ENCLOSURE 1
WATTS BAR NUCLEAR PLANT (WBN)
REVISED RESPONSE TO NRC'S CONCERNS FROM THE AUGUST 23, 1990 AUDIT
SAFETY PARAMETER DISPLAY SYSTEM (SPDS)

The following information revises several of TVA's November 1, 1990, responses (i.e., items 3 and 6 and Appendices A, B, and D) to NRC's request for documented information concerning the eight issues that resulted from the subject audit. The information presented below has been formatted to correspond with the related Standard Review Plan (NUREG-0800) guidelines as headings for ease of review.

WBN SPDS CONTROL ROOM LAYOUT

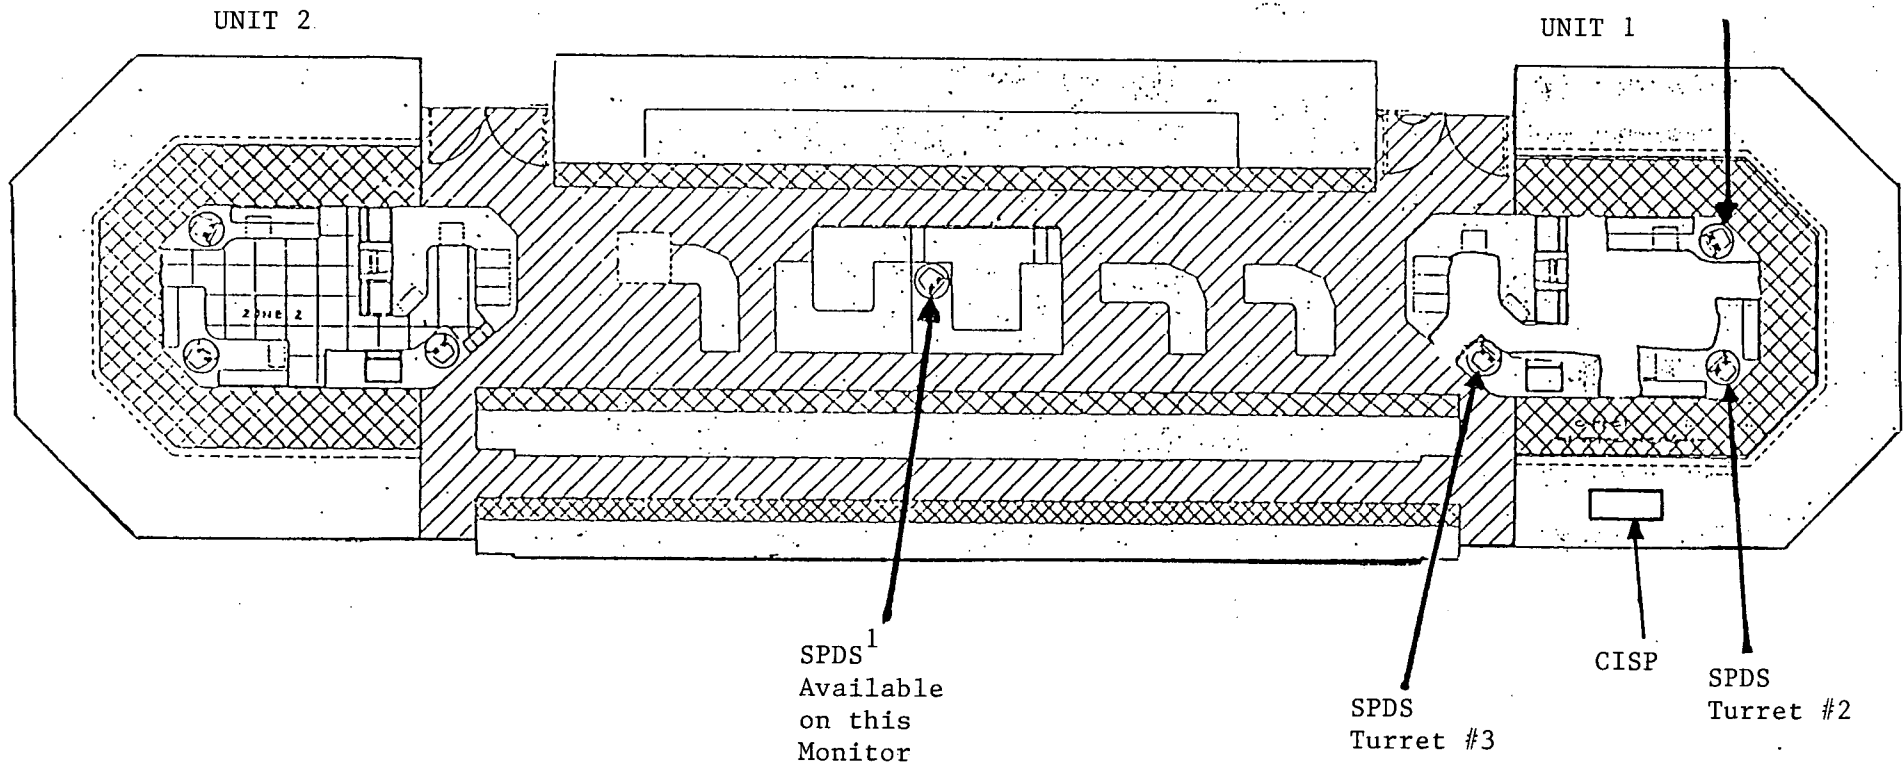
Confirm TVA's commitment to not overwrite (e.g., with temporary error or prompt messages) the SPDS target boxes (located at the bottom left corner of the displays) and provide documentation of TVA's plans to continuously display the status of all five of the critical safety functions.

TVA is to document its process for ensuring that adequate operator review of and input into the SPDS design occurs. In addition, the following specific items were noted:

- Setpoints need to be verified against control room annunciators,
- Status tree logic flows need to be verified against EOI hard copies and in consideration of sensor characteristics (e.g., H₂ analyzers),
- Verify display formats (e.g., 2CS1),
- Dark blue is very difficult to distinguish from the black display background,
- Consideration should be given representative positioning of the page up, down right, and left keys.

The following response supersedes TVA's letter dated June 25, 1985 concerning NRC Question 620.01 (Human Factors Program). To ensure that the status boxes are continuously displayed, the WBN SPDS will be designed to continuously display the SPDS status box on all displays under any conditions. The WBN cathode ray tube SPDS displays are shown in Appendix B. These displays are consistent with the current EOPs. The five critical safety functions will continuously display by virtue of (1) the containment isolation status panels (CISPs) that monitor the position of the containment isolation valves that have automatic actuation from a Phase A, Phase B or containment vent isolation signal, (2) the status boxes that change color in accordance with the Emergency Operating Instructions (EOI) status tree alarms, and (3) an additional box that changes color when any of the other critical parameters (displayed on the plant status screens [2PS1] and/or on the Additional SPDS Parameters) go into the alarm state. These parameters include steam generator (SG) blow down radiation, main steam line (SG discharge) radiation, effluent radiation levels, and residual heat removal. Containment hydrogen is also displayed on 2PS1, but high hydrogen concentration does not result in an SPDS (status box) alarm.

The status boxes ("S", "C", "H", "P", "Z", "I", and "A" (for Additional SPDS Parameters)) will be continuously displayed in the same location on the various displays in the system, including non-SPDS displays.

1. During normal operation, lead and balance of plant (BOP) operators (both licensed reactor operators) have SPDS data provided on control room SPDS displays at CRT's shown as "SPDS #2" and "SPDS #1". The Assistant Shift Operating Supervisor (ASOS) also has SPDS data provided at "SPDS CRT #3,".
2. During an emergency, the lead and BOP operators are standing at the control boards. During this situation, typically, the ASOS serves as the procedure reader utilizing either SPDS Turret #1 or #2, allowing the remaining turrets to be utilized by other licensed crew members to assist and consult.
3. The CISPs that monitor the position of the containment isolation valves that have automatic actuation from a Phase A, Phase B, or containment vent isolation signal is located as shown and is high enough to be visible from the three SPDS CRT locations.
